# ASSESSMENT REPORT

# HUNTLEE NEW TOWN STAGE 1 MP 10 0137 MOD 6

Figure 3: Proposed Subdivision – Town Centre (source: Proponent's application)

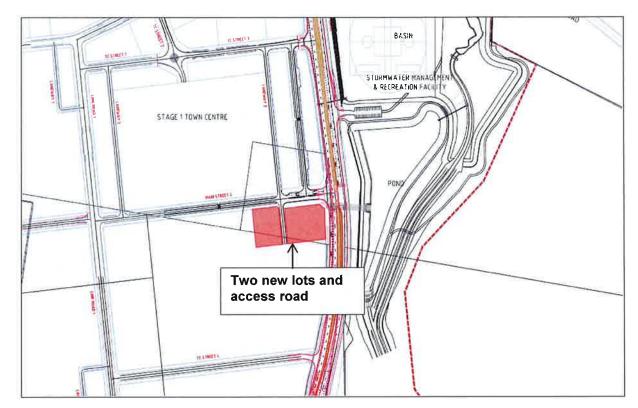
Issue	Consideration	Recommendation
Subdivision Layout	<ul> <li>The proposed modification seeks approval to subdivide a super lot within the Town Centre into two smaller commercial lots and provide a new access lane. The Department considers the proposed subdivision is acceptable because:         <ul> <li>it is a minor change, which would allow the site to be occupied by future commercial tenants, consistent with the approved use of the Town Centre site; and</li> <li>it is consistent with the Huntlee Development Control Plan 2013 (HDCP 2013) in terms of the layout of the retail core and the road network hierarchy (refer to Appendix A).</li> </ul> </li> <li>The proposed modification also seeks approval to include one additional residential lot in sub-stage 4. The Department considers the proposed subdivision is acceptable because:         <ul> <li>it would result in a total of 1,473 lots (within Stage 1), which is the same as originally approved;</li> <li>It would not result in any additional traffic impacts beyond those already assessed and approved; and</li> <li>it is consistent with HDCP 2013 in terms of the minimum lot dimensions and would not compromise compliance of the adjoining</li> </ul> </li> </ul>	Condition A2 is amended to incorporate the modified subdivisio layout in Stage 1 of the Huntlee Masterplan.

Figure 5: Traffic Infrastructure Upgrade – Stage 1 (Source: Proponent's Modification request)

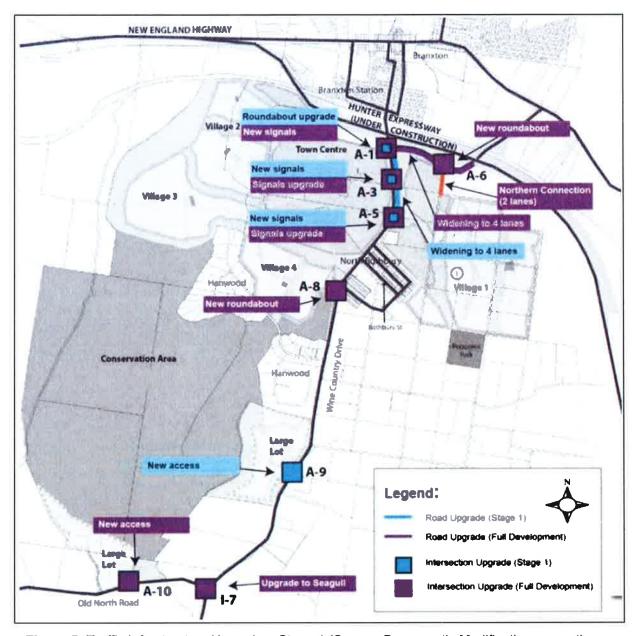
**RMS** initially raised concerns with the traffic analysis and modelling undertaken by the Proponent. However, following further consideration of those issues, RMS raises no further concern, subject to specific changes to the road infrastructure upgrade requirements.

The Proponent submitted a Response to Submissions (RtS) dated 6 December 2016, which included an updated Traffic Report in response to concerns raised by RMS. The RtS also revised the lot thresholds for the delivery of road infrastructure in response to concerns raised by the Department. Those aspects are addressed in **Section 8** below.
